Product / Process Change Notification

N° 2019-051-A

Introduction of an Additional Assembly And Final Test Location at Jiangsu Changjiang Electronics Technology Co., Ltd.(JCET) and HANA Semiconductor (Ayutthaya) Co., Ltd. for dedicated SOIC Products in PG-DSO-8/14

Site Code: H

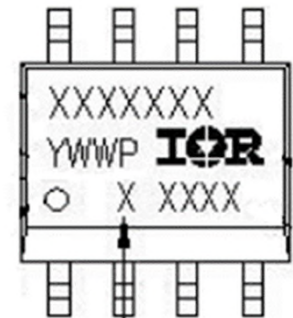
Marking Comparision

PG-DSO-8

PG-DSO-14

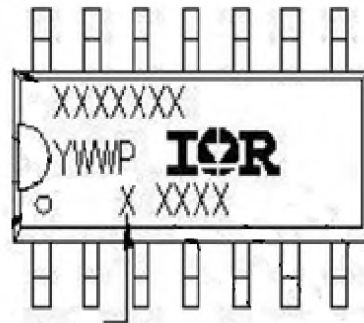
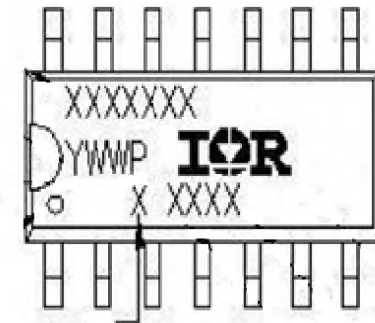
Marking Comparision
